Interactive comment on “Vulnerability of groundwater resources to interaction with river water in a boreal catchment” by A. Rautio et al.

A Author Comment.

The manuscript HESSD-2014-556 “Vulnerability of groundwater resources to interaction with river water in a boreal catchment” by A. Rautio, A.-L. Kivimäki, K. Korkka-Niemi, M. Nygård, V.-P. Salonen, K. Lahti, and H. Vahtera

Fig. 1.

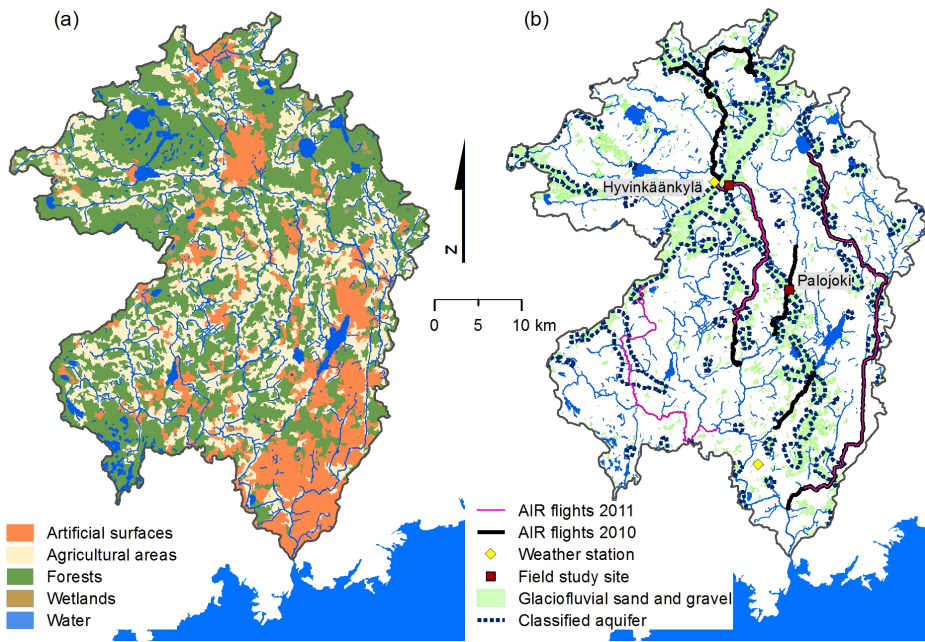
p. 2439, L. 21. Cover-moraine sheets and end-moraine ridges need to be explained in Figure 1a. These two geomorphological elements are not shown on the legend of Fig 1a ?

Fig1a. The legend is a mixture of lithological units and geomorphological units Fig 2b. Show the extension of the classified aquifers with a more pronounced signature. The dashed line used to outline the classified aquifers is difficult to see. I will suggest that

We have added references in the text followingly: bedrock terrain and glacial deposits forming cover-moraine sheets (glacial till in Fig. 1a) and end-moraine ridges (glaciofluvial sand and gravel in Fig. 1a) (Tikkanen, 1989) (Fig.1a).

Fig. 2.

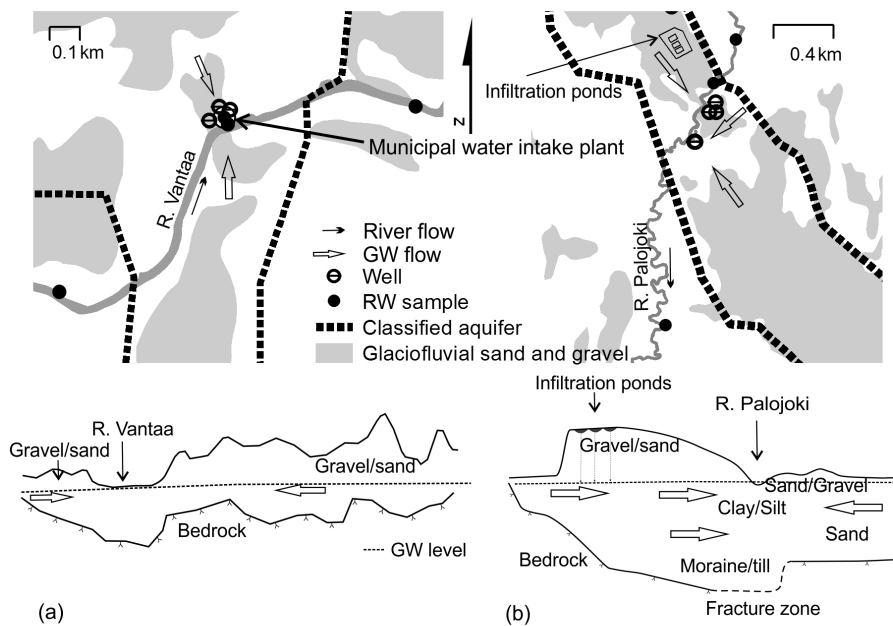
p. 2440, L. 2-5. Delineation of aquifers is not given in Fig 2b and not in Fig 1.

you use oblique hatching as you use in Korkka-Niemi et al (2012, Figure 1). Explain “classified aquifer” – not explained in text. In the legend: IR flights 2011 and IR flights 2012 should be changed to AIR flights 2011 and AIR flights 2012

Yes, it is true that the delineation of 29 aquifers are not given in Fig. 2b or Fig 1. However, we have referring the municipal water companies which are placed in the Fig. 1a.

The classified aquifers have been explained in figure caption of 2b. However, we have left the classified aquifer symbol in previous for as it is the official symbol used by Finnish environmental agencies. We have changed IR flights 2010 and IR flights 2011 to IR flights 2010 and AIR flights 2011.

Fig. 3.

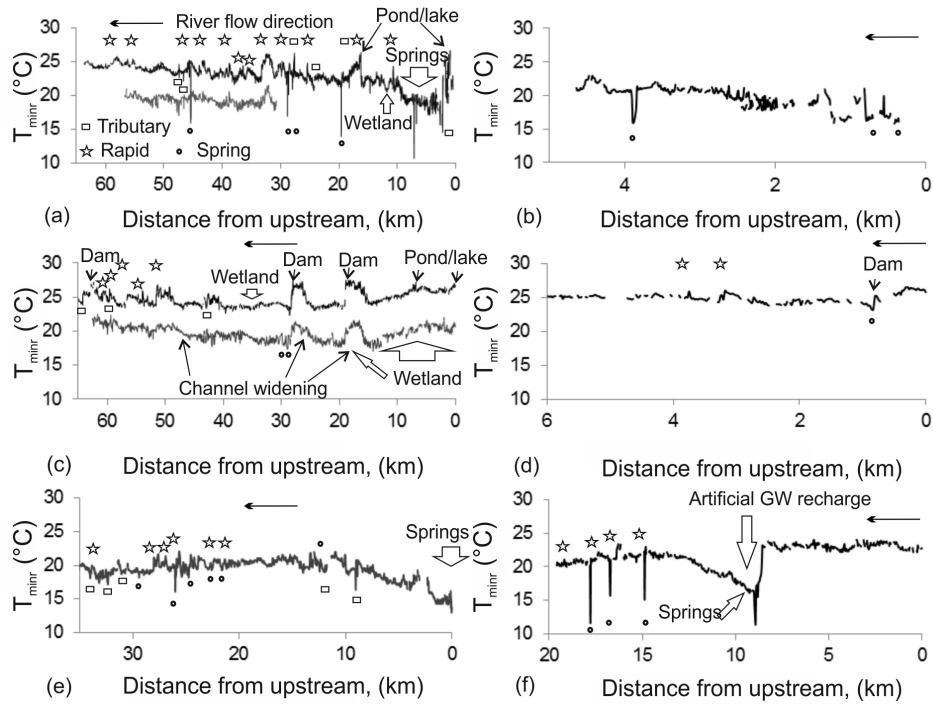
P. 2440, L. 25. Jäniksenlinna aquifer is not shown in fig 3b.

Fig 3. Indicate the area with the classified aquifers with another signature. It is impossible to see the position of the municipal intake plant and wells as they are grouped too close in Fig 3a and 3b.

The classified aquifer in Fig. 3b is Jäniksenlinna aquifer. We have added followingly: The recharge of natural GW in the shallow and unconfined Jäniksenlinna aquifer is approximately 4000 m³ d⁻¹ (Hatva, 1989) (classified aquifer in Fig. 3b).

We have left the symbol in previous form. Unfortunately, production well are close to each other and the municipal water intake plant well symbol is covered by them. We have added arrow to pointed out the location of intake plant.
